Subject: Class 1 Permit Modification Notification to the Waste Isolation Pilot Plant Hazardous Waste Facility Permit Number: NM4890139088-TSDF

Class 1 Permit Modification Notifications

**Waste Isolation Pilot Plant
Carlsbad, New Mexico**

September 2015

**Figure A4-2
WIPP Traffic Flow Diagram**

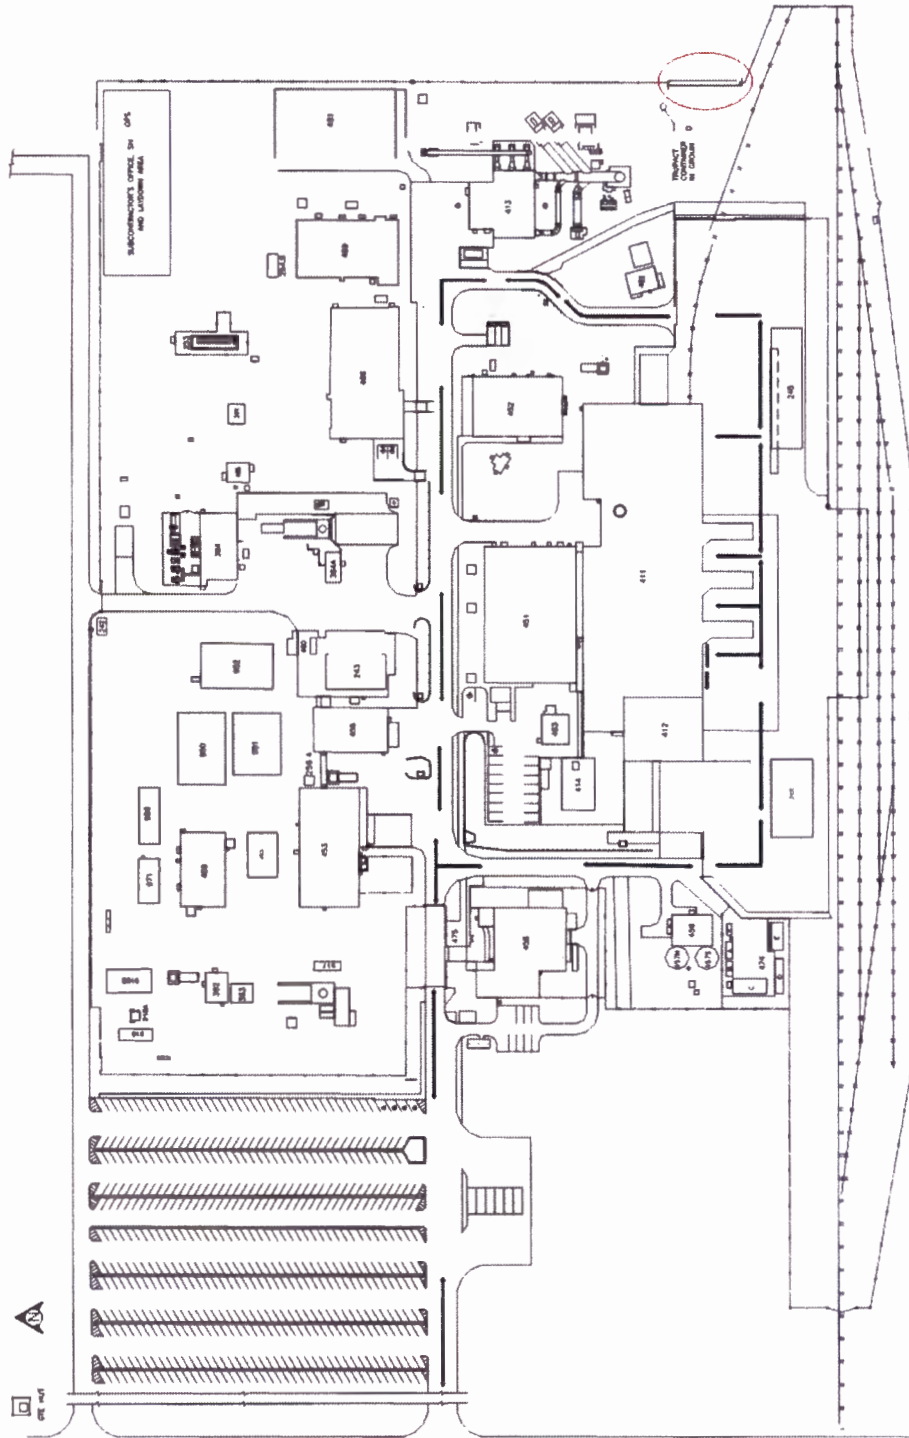
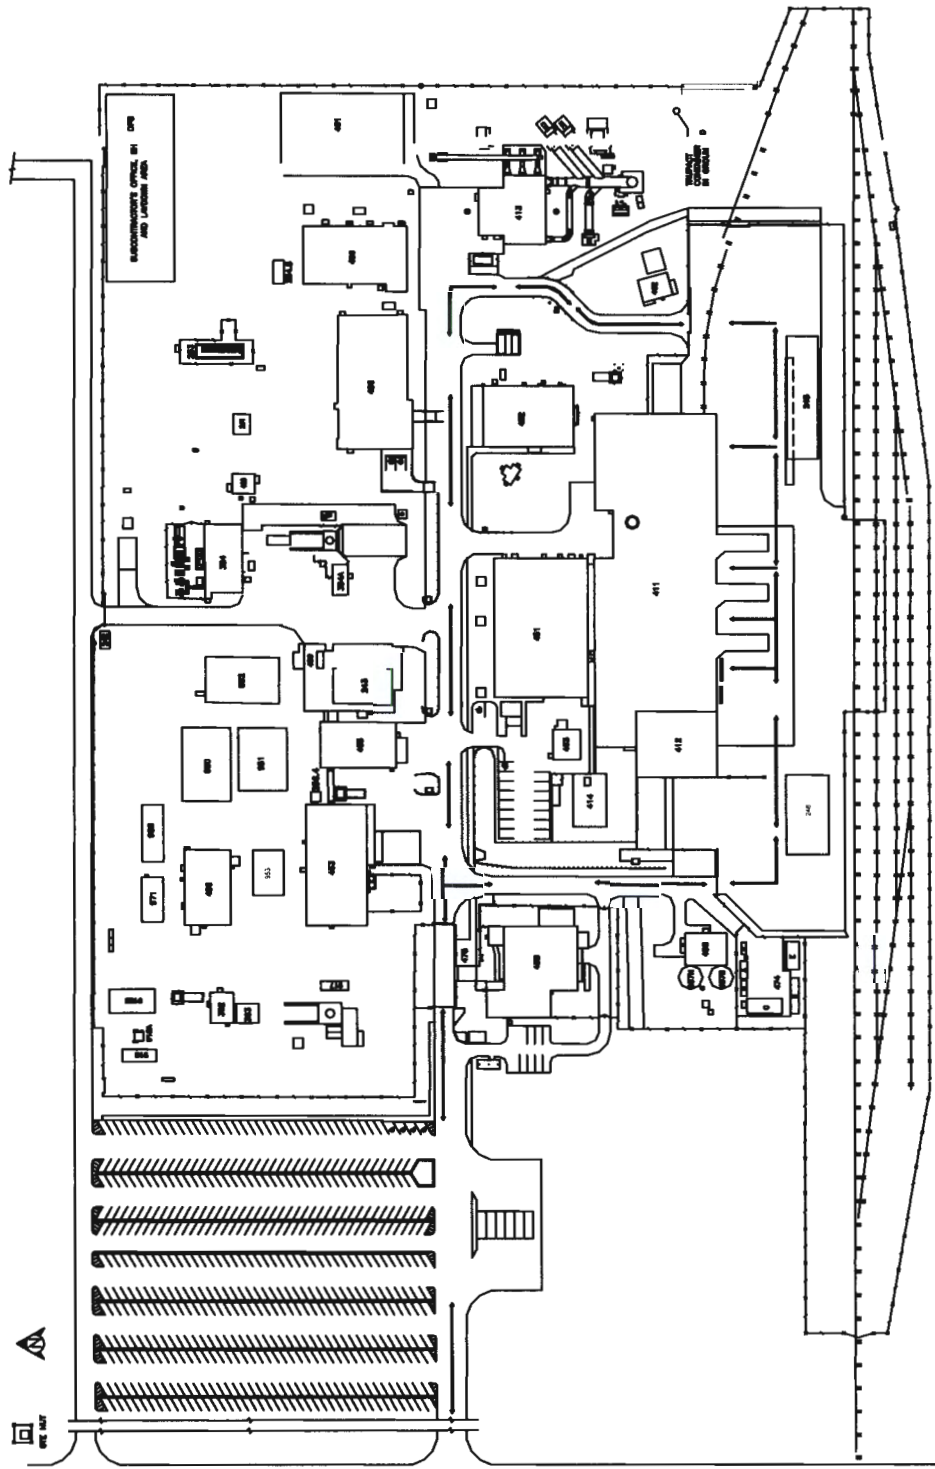
This modification updates Attachment A4, Figure A4-2 *WIPP Traffic Flow Diagram* to show the new east gate which is scheduled to be installed in the east fence line.

This change is needed to update the traffic flow diagram to accurately reflect the new east gate which will be used to allow delivery of large components and equipment for the new underground ventilation system. Other than the addition of the new east gate, there are no other changes to this figure. Other portions of the Permit related to fence security will remain in effect. This gate is not intended for waste handling activities. Updates to similar figures in Attachment D of the Permit will be made at a future date when the Attachment is revised.
